SERVICE BULLETIN SB00.30

Machines / Models: MB20/26

PURPOSE: To remove the risk of damage to the main harness cable by the action of the mast movement.

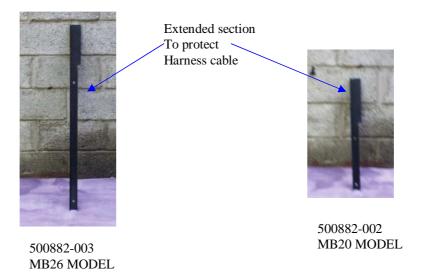
- 3. Remove the key from the lower control box and press in the emergency stop.
- 4. Using a 5mm Allen key, remove the two countersunk bolts shown below. The old trunking cover can now be removed. The trunking cover in question is the one closest to the lower control box side of the machine. Discard old trunking cover in an environmentally friendly manner.

5. Fit the new trunking cover, shown below, and secure using previously removed countersunk bolts.

PARTS REQUIRED: 1 off Trunking cover.

Part No. 500882-002 MB20 **Part No.** 500882-003 MB26
